Site Plan Application – Residential, Multi-family

Staff Report for Plan Commission, 8/12/15.

**To:** Chris Tollaksen – Zoning Administrator – City of Wisconsin Dells  
**From:** Chuck Bongard, P.E.  
**Subject:** Fitzgerald Road Development  
**Date:** August 7, 2015

C-102

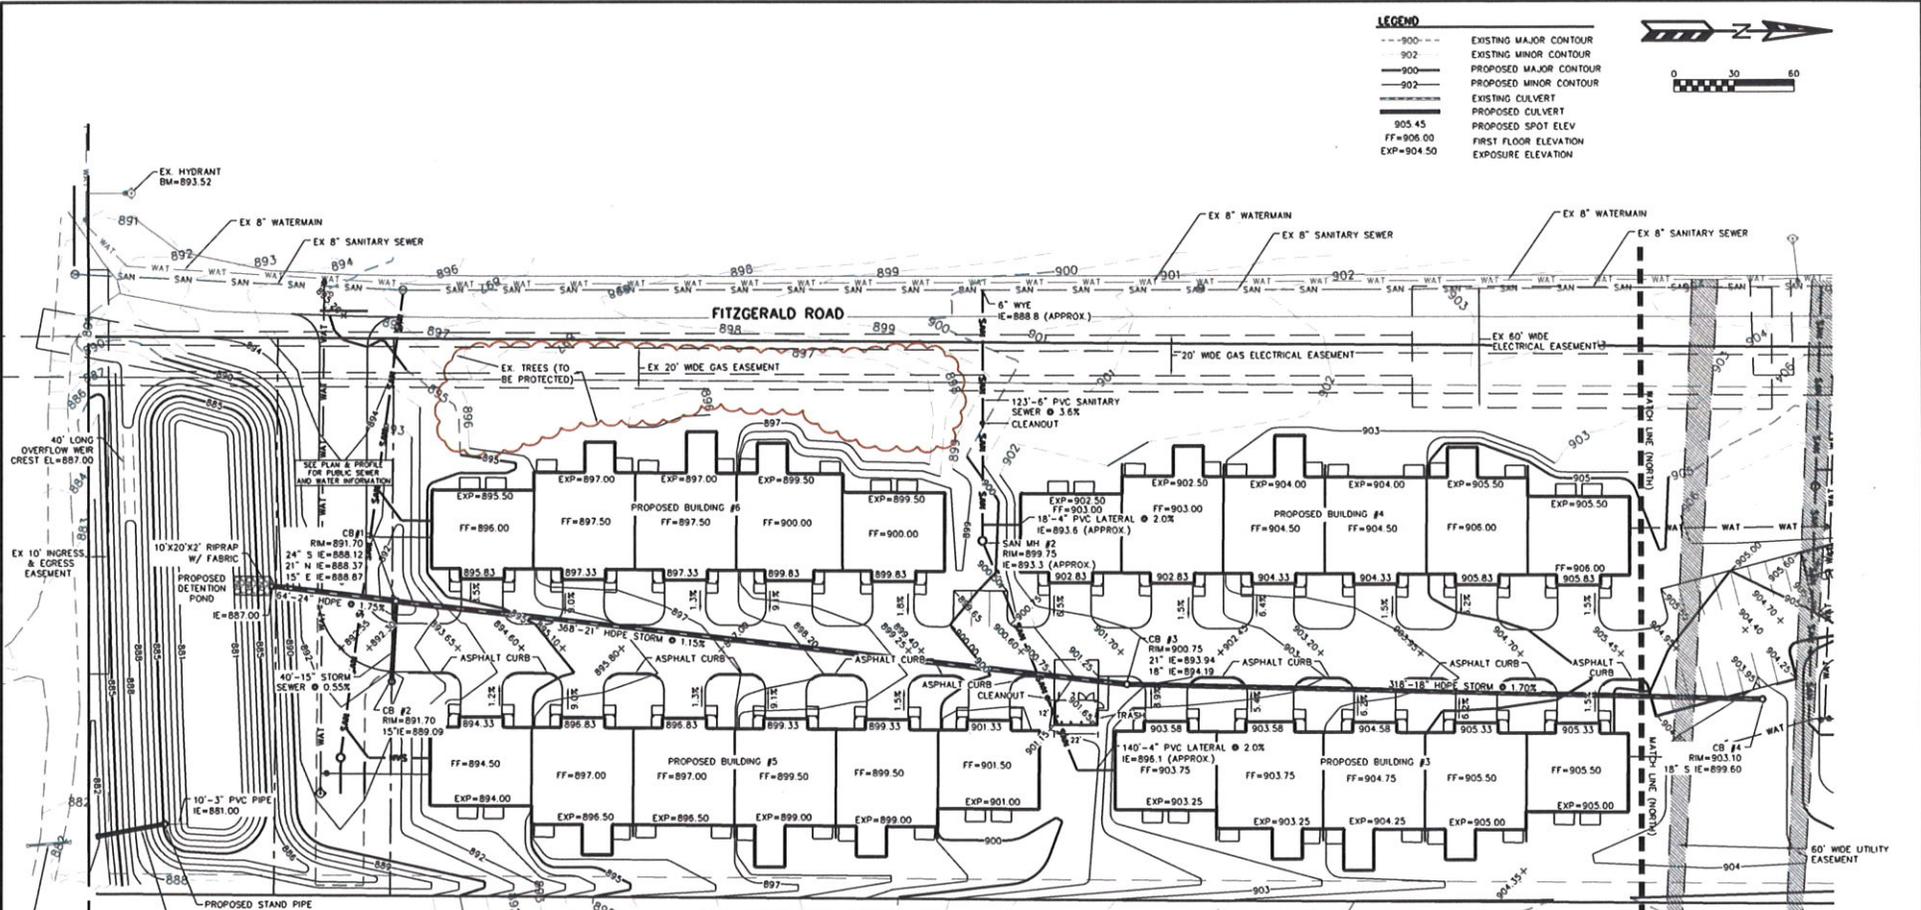
There is an internal storm sewer system with a minimal number of collection inlets shown. The north one-third of the property drains to one inlet. As shown the main drive will be a flume that will collect and convey half of the roof water and all of the driveway water to 4 collection points. I note that several of the driveway apron slopes shown are under 2 percent which means that the floor of the garage is approximately 6-inches above the flow line of the main drive. Designer should verify the carrying capacity of the driveway flume or consider raising the floor elevation on those units.

A drainage swale is shown along the east property line which will convey the east half of the roof drainage for the east row of houses. The west half of the roof drainage from the west units will flow toward Fitzgerald Road and then south to the entrance road. That road drainage then is directed onto the site and collected into a catch basin into the detention pond.

**C-103**

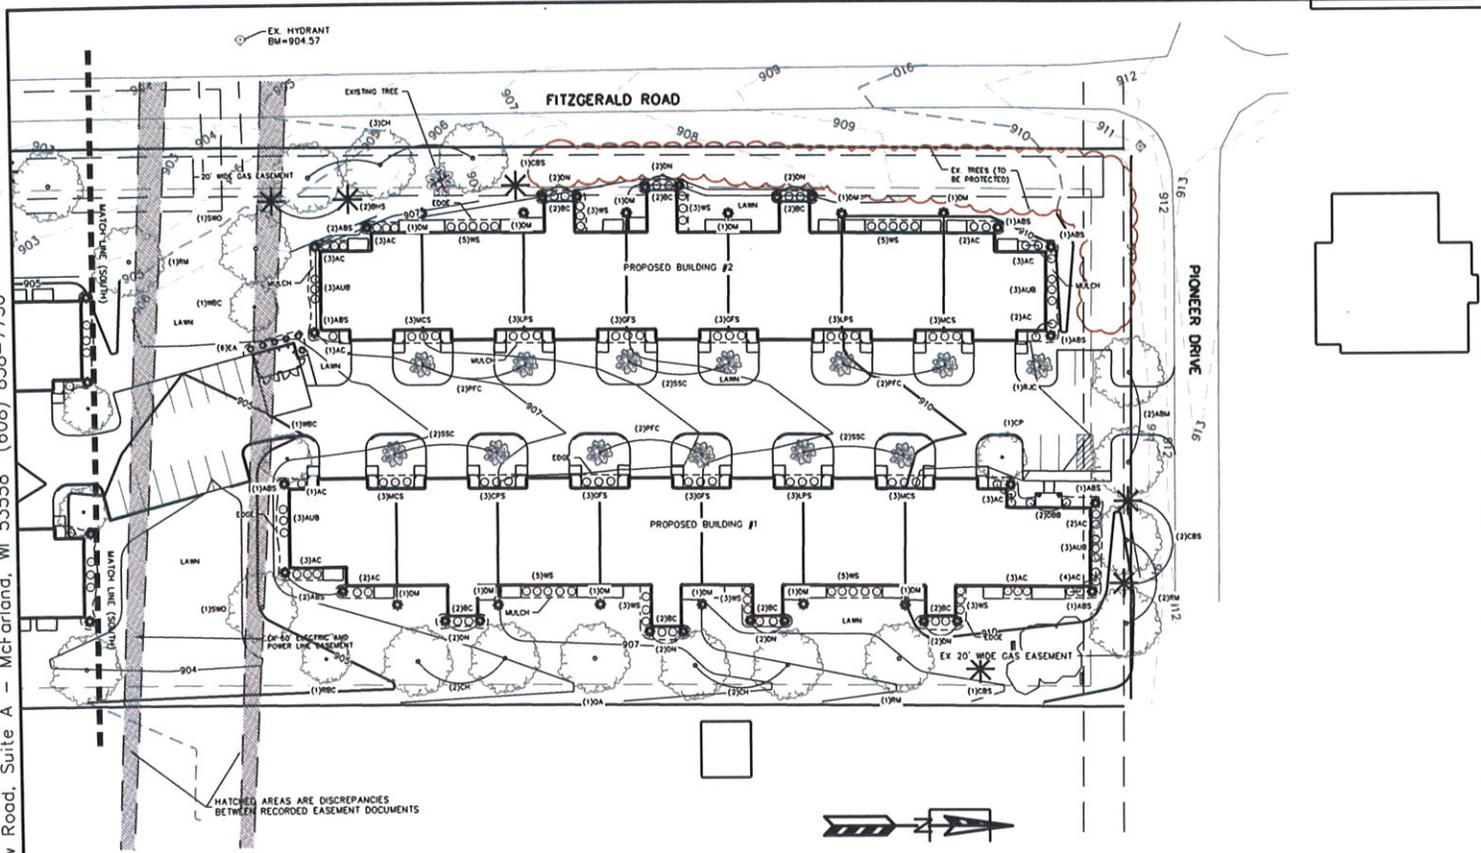
The existing site is relatively flat and drainage is from north to south. A significant detention pond is proposed at the south end of the property and the summary provided indicate that it will maintain the flow rates after development to the existing runoff rates up to and including the 100 year rainfall event. I was not provided nor did I review the actual calculations that were the basis of this summary but the results seem reasonable given the size of the pond shown. The pond outlet is a 15-inch culvert pipe shown to discharge near the south property line. There is also a pond overflow that is shown to be discharged to the east. Based on my observation at the site the majority of the drainage currently exits the site to the east where the overflow is being directed. The drainage along the private drive to the south of the property is not well defined and the pipe

discharge at the proposed location could cause issues there. I recommend that the pipe outlet be re-oriented to the drainage swale being graded to the east to the historic point of discharge.

There is a 66 foot road right-of-way shown at the south entrance to provide connectivity from Fitzgerald Road to remaining lands to the east of this project. This right-of-way will create a parcel that the pond will reside on. Will this parcel be an outlot? Will that be dedicated to the City? Who is responsible for maintenance of the storm detention basin?
